Access Compliance Report

Public Rights-of-Way

(Curb Ramps)

Intersection ID: 42722	Main Street: WAKEROBIN_LN	Cross Street: BACK_CREEK_CHURCH_RD	Location: N
ADA ID: B913C4C0DBAD	Ramp Type: Perp	Initial Pass/Fail: Fail	Overall Compliance: No
Severity Score: 8.75			
Codes/Mitigation Info/Possible Solution		Field Measurements/Component Compliance

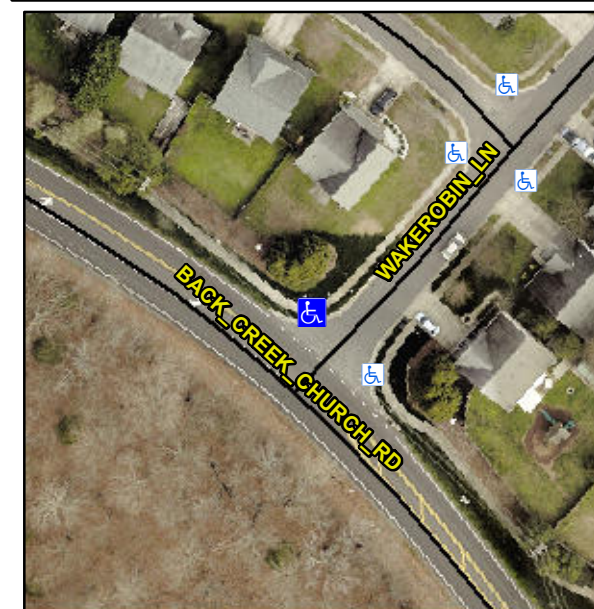
R304.5.1

Remove & Replace Entire Ramp.
